***MODIFICATION REQUEST:
Baileys Marine Supply and Refuelling
Facility
White Bay, Berth 6
(MP06_0037 MOD 4)***

***Caretaker's accommodation, new buildings &
increasing dry boat storage***

Director-General's
Environmental Assessment Report
Section 75W of the
Environmental Planning and Assessment Act 1979

March 2014

Figure 10: Site Location and Access Routes

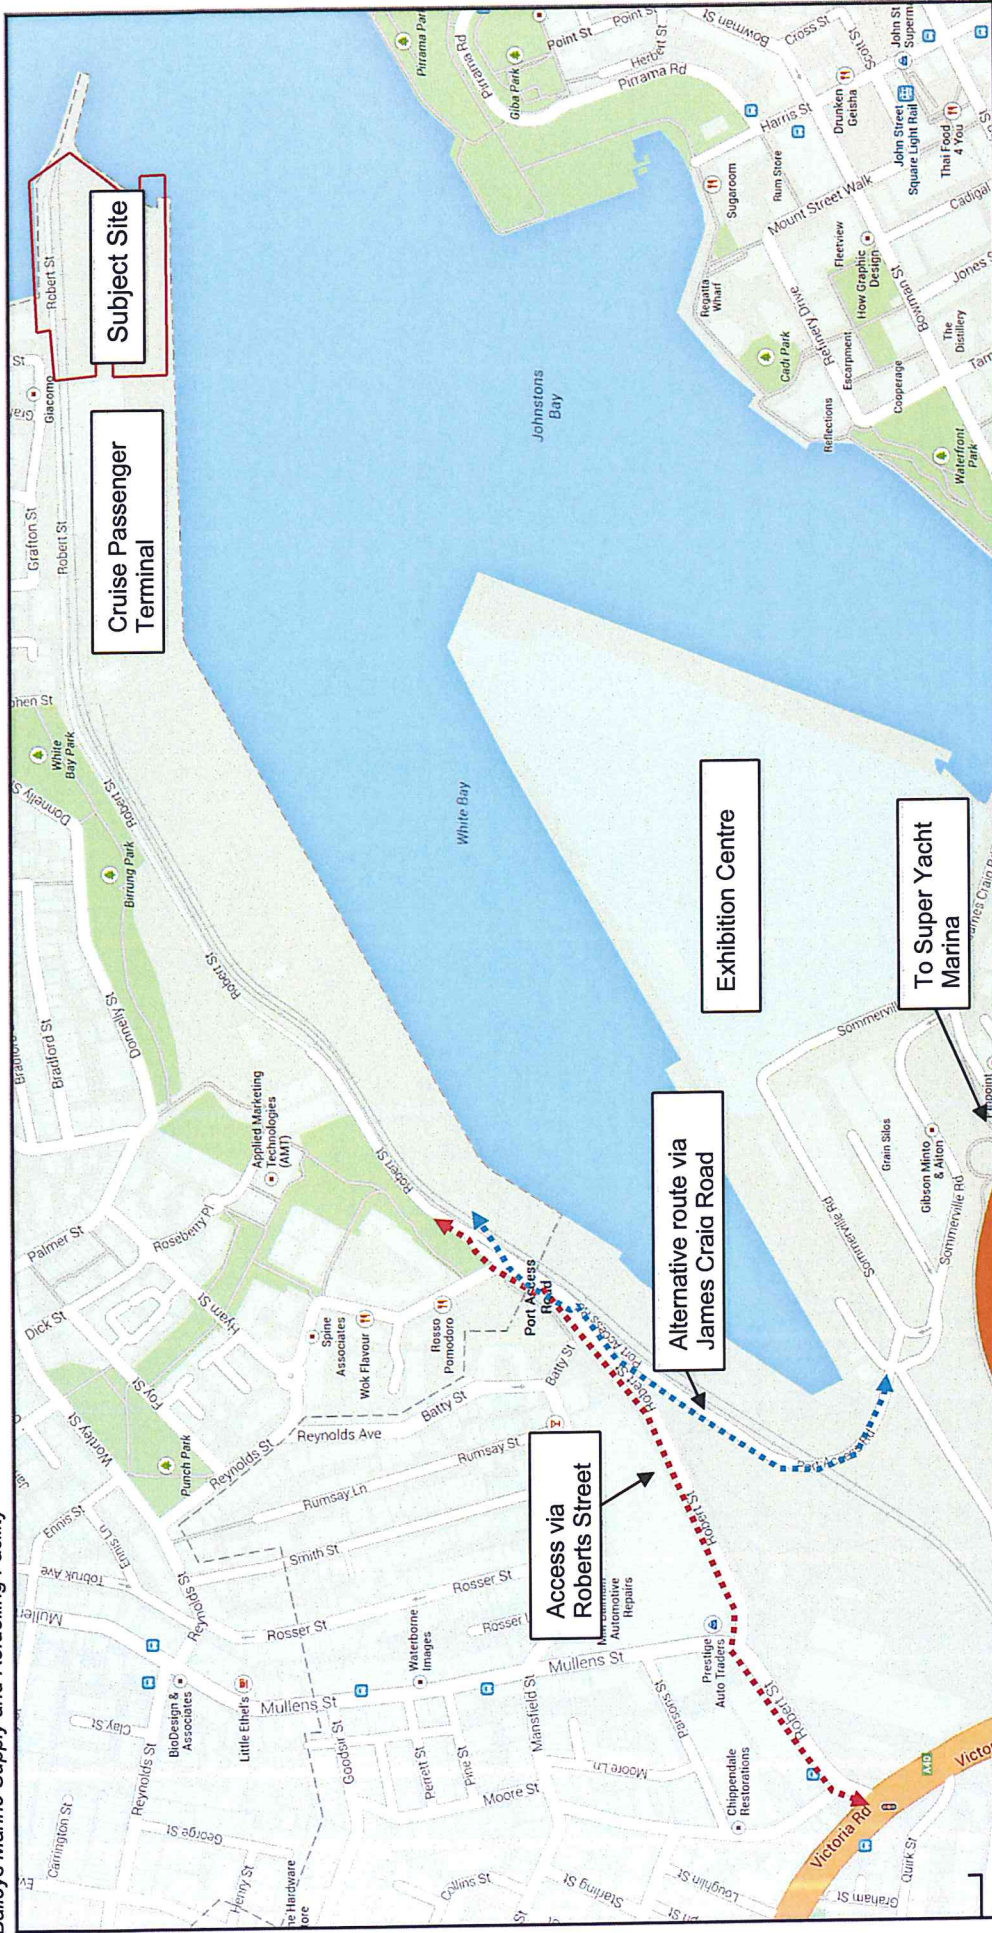
In response to the exhibition of the modification application, a number of concerns were raised by Council and the public, regarding the traffic impacts of the proposal. Council raised concerns that existing problems at the intersections of Robert Street/Victoria Road and Robert Street/Mullens Street would be exacerbated by the proposal. Council also raised concerns that the traffic analysis did not take into account the effects of already approved development in the vicinity of the site. A submission made on behalf of a local business also raised concerns with the adequacy of the traffic assessment, particularly in relation to impacts on James Craig Road, and with regard to the assumptions used to derive peak hour trip generation rates. However, despite these concerns, RMS did not have any concerns regarding the traffic impacts of the proposal, although suggested that a Road Occupancy Licence (ROL) could be obtained for any activity likely to impact on the operational efficiency of the road network.

Whilst Planning and Infrastructure did not have any concerns about the peak hour trip generation rates used by the proponent's traffic engineer, a request was made to the proponent that it provide more information on the performance for all relevant intersections, including those on James Craig Drive, and consideration of traffic impacts in light of recently approved developments in the immediate vicinity (**Figure 10**).

In response, the PPR substantially reduced the number of dry berths proposed. Based on the reduced traffic movements and the deletion of access from James Craig Road, the proponent submits that it is not necessary to provide any additional traffic analysis. The proponent noted the following:

- The proposal results in only a very minor net increase in vehicle movements (a net increase of 4 vehicle movements a day to a total of 134 movements);

- A redistribution of movements throughout the day results in an additional 11 movements predicted during the peak period, however this figure is conservative and indicative of a worst case scenario. It equates to less than 0.2% of movements through the Roberts Street / Victoria Road intersection and less than 0.7% of movements during the Roberts / Mullens Streets intersections at peak hours;

Planning and Infrastructure agrees that the modification request (as amended) results in only a very minor increase in vehicle movements within the locality. Furthermore, it is noted that due to a change in the nature of activities on the site, there is also a change in the type of vehicles accessing the site. The proponent has found that since it has commenced operations, there is very limited demand for trucks accessing the site and, as such, the current traffic assessment predicts only 10 large truck movements per day (reduced from 70 under previous applications). Therefore, although the proposal results in a small increase in total daily vehicle movements, it results in a substantial reduction in large truck movements so that the actual effects on the local road network outside of peak hours would be materially *improved* as compared to impacts predicted in earlier approved applications.

During peak hours it is acknowledged that there would be a minor impact on nearby intersections and that the Roberts Street / Victoria Road intersection is already operating at or beyond capacity with very poor levels of service and that the Roberts / Mullens Street intersection is operating at or past capacity on certain approaches during peak hour. However, the predicted additional 11 vehicle movements which would account for significantly less than 1% of movements through these intersections during peak hours, is considered to be very minor, and does not warrant additional analysis, intersection upgrades or refusal of the application.
